FARRAGUT VISUAL RESOURCES REVIEW BOARD AGENDA

Farragut Town Hall
Board Room
Tuesday, August 22, 2023
7:00 p.m.

TO: Farragut Visual Resources Review Board
FROM: Bart Hose, Assist. Community Development Director
SUBJECT: Regularly Scheduled Meeting - Tuesday, August 22, 2023, at 7:00 p.m.

LANDSCAPE PLAN
2 PROJECT ENTRY SIGN- ELEVATIONS
SCALE: 1/4" = 1'-0" (SIGN TO BE DOUBLE SIDED)

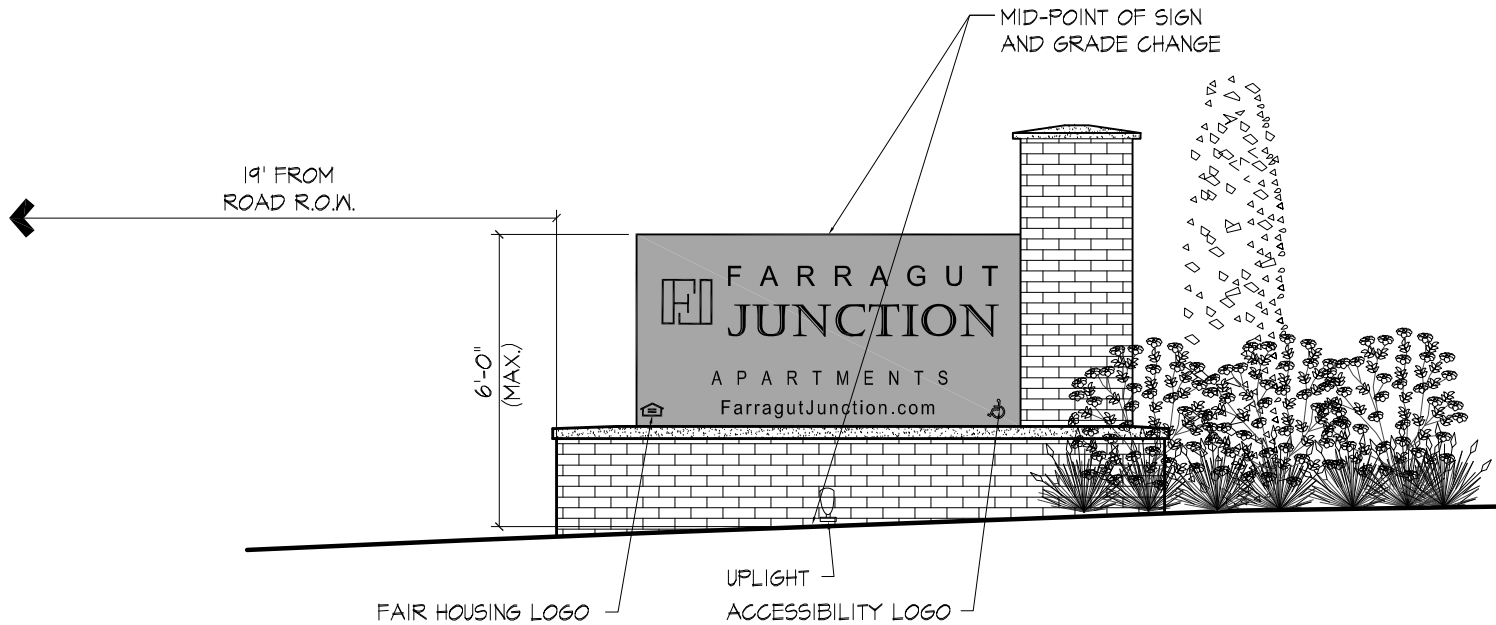
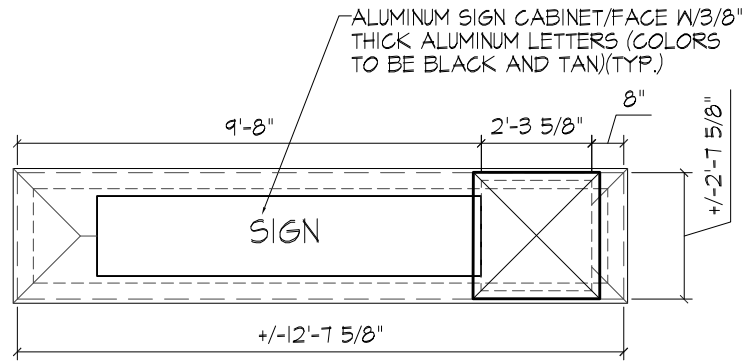
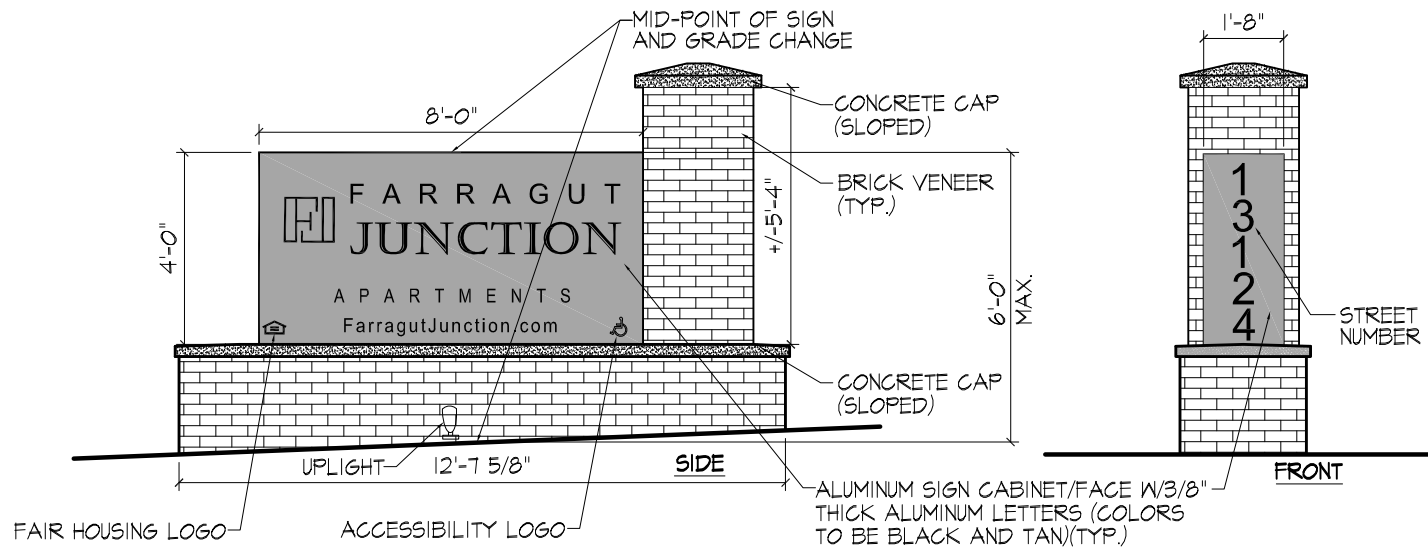
There are several issues that need to be addressed before approval. These include:
 1. Revising the lighting plan to include compliant lights (max 850 lumen value)
 2. Verifying that the brick used on the sign base will match the brick being used on the buildings.

3. Verifying and ensuring that the maximum sign height is 6 feet on the tallest side of the sign and that the base is a minimum of 2 feet high on the shortest side of the sign.
4. A determination needs to be made regarding the inclusion of address numbers. The address number could be confusing because the sign will be close to, and visible from Watt Road, but the address is based on a named private drive that is internal to the development. If the address number is required, it will need to be at the top of the sign.

**SIGN
1**

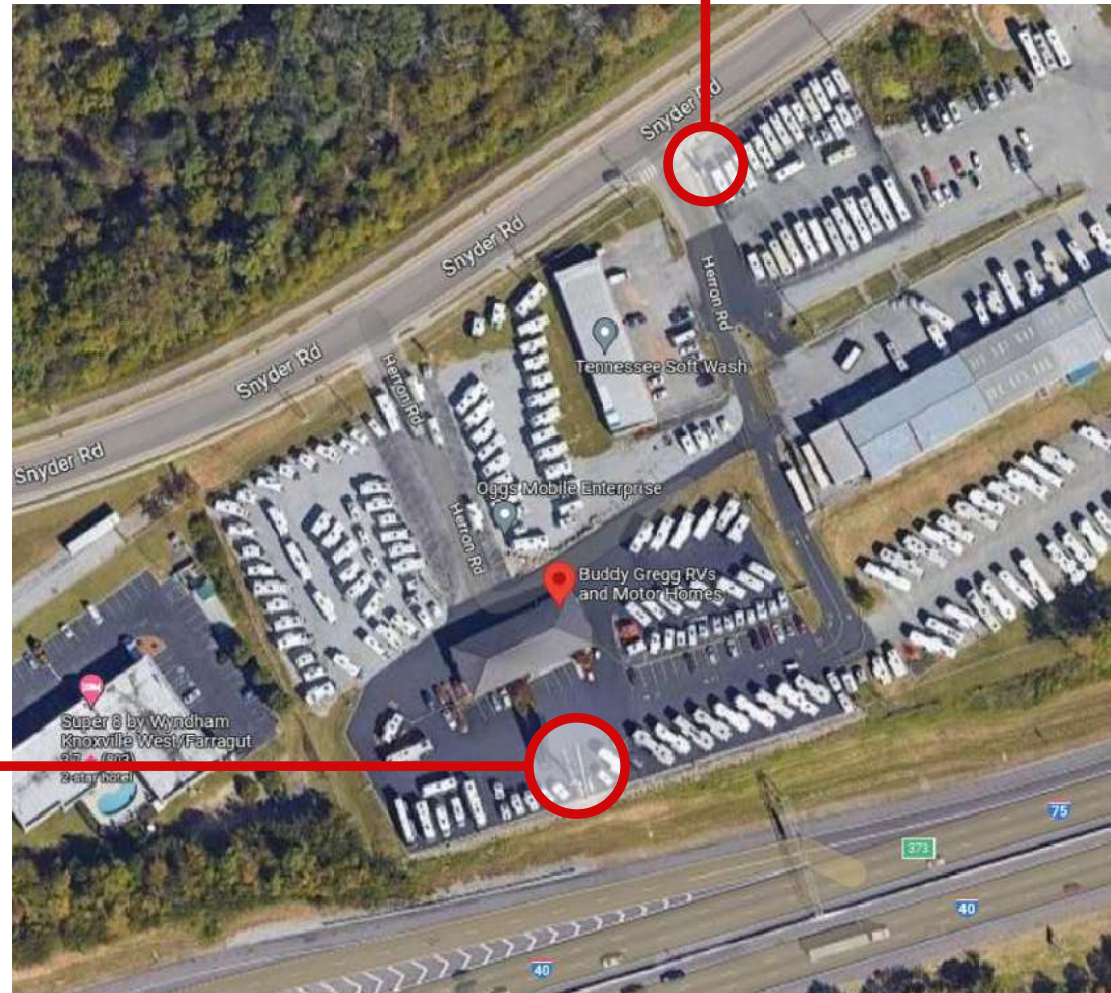
The applicant is requesting approval to reface an existing on-premises “billboard type” interstate sign located on their site (formally Buddy Gregg RV). The sign in question was approved as an on-premises ground mounted interstate sign by the Farragut Board of Zoning Appeals as a special exception in 1986. As such, the sign structure can remain on site and be refaced as requested by the applicant. No changes to the size, structure, or mode of lighting (external) to the sign are proposed. The staff recommends approval of the new sign face.
